DEVELOPMENT REVIEW BOARD

Planning Dept. - Major Case Comments

Project Number: PR-2021-005597

Application Number: SD-2022-00026 – PRELIMINARY PLAT

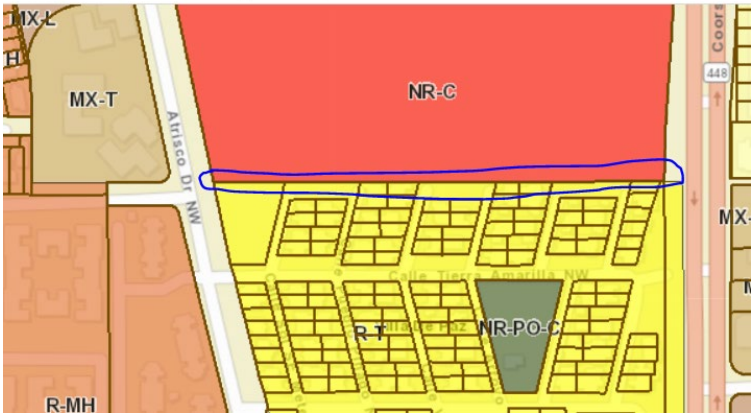
- **Updated 3/17/22**: The IDO requires a landscaped edge buffer of 15 feet when non-residential development is next to low density residential development. Lots along your southern boundary will need to provide a 15-foot landscaped buffer to the R-T zoned residential project to the south. Please make sure the edge buffer is accommodated in the southern lot sizes. See IDO 5-6(E)2.
